PRODUCT CHANGE NOTIFICATION (PCN)

A-MCSP-80050
MODULAR CABLE

CHANGE NOTIFICATION: PCN 20220425_A-MCSP-80050

DESCRIPTION OF CHANGES:
CHANGE OF DATA SHEET
CHANGE OF DATA SHEET
New Draw.-No. ASS_7425_CArev07

A-MCSP-80050 OLD VERSION

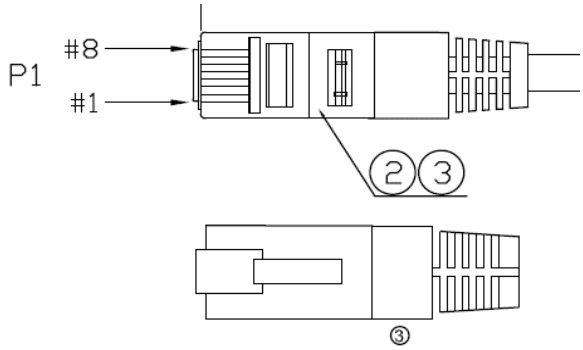
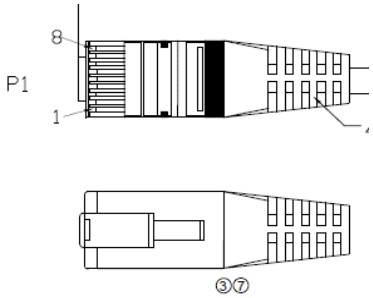
NO	PART NO	DESCRIPTION	QTY	UNIT
	3	mold	PVC,50P	9.0	G
	2	plug	8P8C plating gold 3U" with metal shield	2	PCS
⑤	1	cable	FTP (26AWG*1P)*4+D+A+PVC, OD:5.2±0.2mm CAT5E	2.0	M

NO	PART NO	DESCRIPTION	QTY	UNIT
⑦	4	AL-Foil	Double-sided conductive aluminum foil	2	PCS
⑦	3	mold	PVC,65P	AR	G
	2	plug	8P8C plating gold 3U" with metal shield	2	PCS
⑦⑤	1	cable	CAT5E F/UTP (26AWG*1P)*4+D+A+PVC, OD:5.2±0.2mm	AR	M

Drawing-No.
ASS 7425 CA

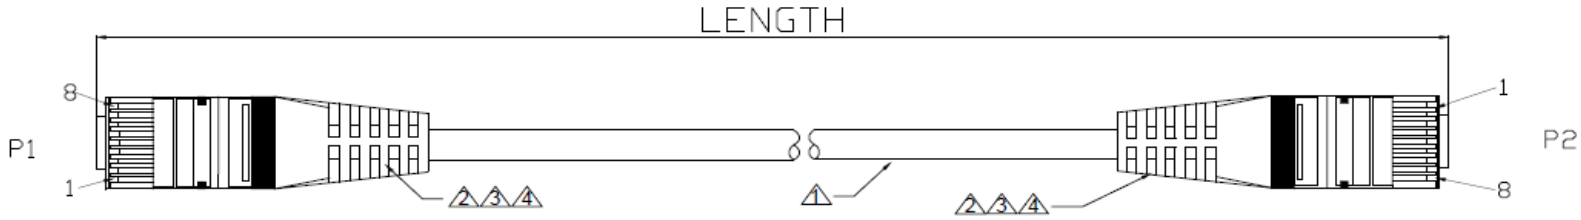
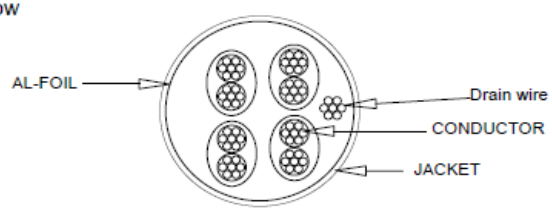
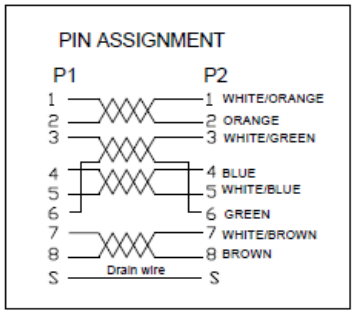
Scale	FREE	⑦	Change the plant	12.04.2022	Luca		Date	Name
TOLERANCE		⑥	Clarify the tolerance	23.08.2018	Segal	Drawn	26.06.2015	Joanna
X.	±X	⑤	Add "CAT5E"	20.10.2017	Stephon	Approved	12.04.2022	Luca
X.X	±X	④	Add length for 20M and 30M	20.09.2017	Fred			
X.XX	±X	③	remove mark on the mould	29.06.2016	Joanna			
DIM	TOL	②	Add length for 300mm	18.05.2015	Joanna			
ANGLE	±X°							
Angle	TOL	Id.	Modification	Date	Name

NO	PART NO	DESCRIPTION	QTY	UNIT
⑦	4	AL-Foil	Double-sided conductive aluminum foil	2	PCS
⑦	3	mold	PVC,65P	AR	G
	2	plug	8P8C plating gold 3U" with metal shield	2	PCS
⑦⑤	1	cable	CAT5E F/UTP (26AWG*1P)*4+D+A+PVC, OD:5.2±0.2mm	AR	M
